# COMMUNITY DEVELOPMENT DEPARTMENT REPORT

HEARING DATE: 7/8/2025

APPLICANT: Engineering Solutions

SUBJECT: H-2024-0070  
Dayspring Subdivision – AZ, PP

## E. Common Driveway Exhibit – REVISED

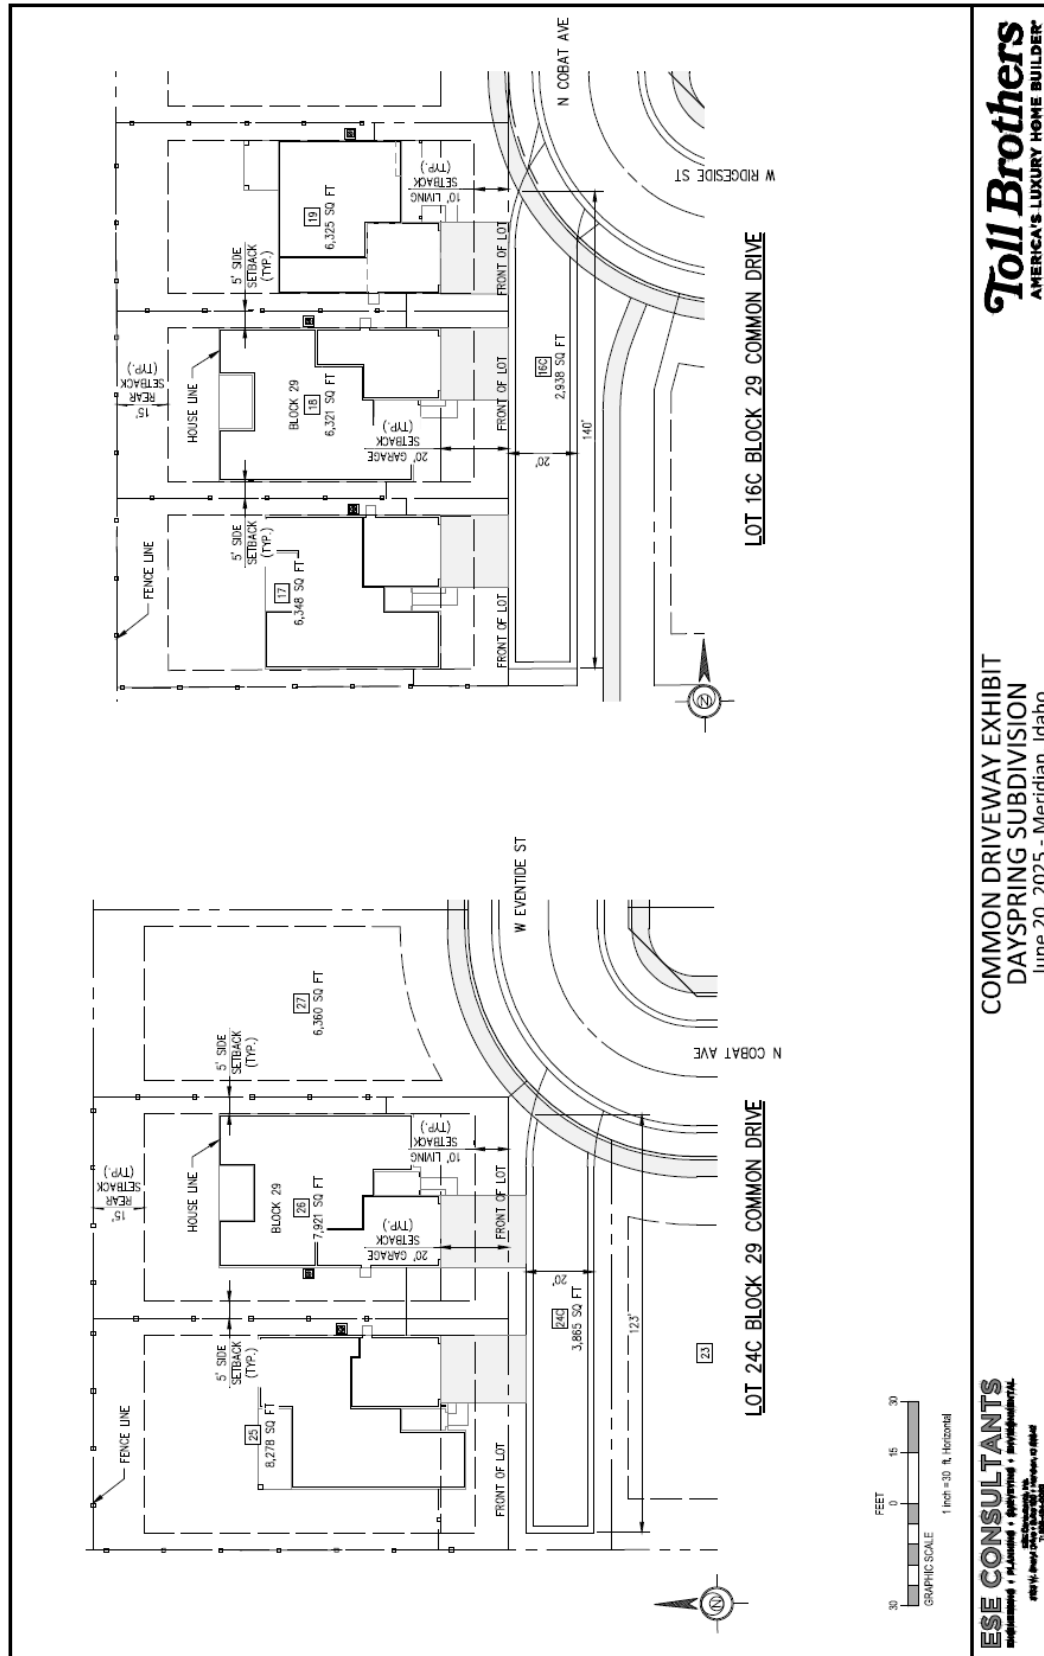
Six (6) common driveways are proposed; see exhibit in Section VII.E below. **All common driveways are required to comply with the standards in UDC 11-6C-3D, which require driveways to be a minimum 20’ in width. The common lots for the driveways also need to extend all the way to the back lot. If solid fencing is proposed adjacent to common driveways, a minimum 5-foot wide landscape buffer planted with shrubs, lawn or other vegetative groundcover should be provided between the driveway and fence. The common driveway exhibits, preliminary plat and landscape plan should be revised to comply with these standards with submittal of the final plat application.**

- 8. All common driveways shall comply with the standards listed in UDC 11-6C-3D. *A revised common driveway exhibit(s) shall be submitted ~~prior to the City Council hearing~~ with the final plat application that incorporates the changes noted in Section III above.*
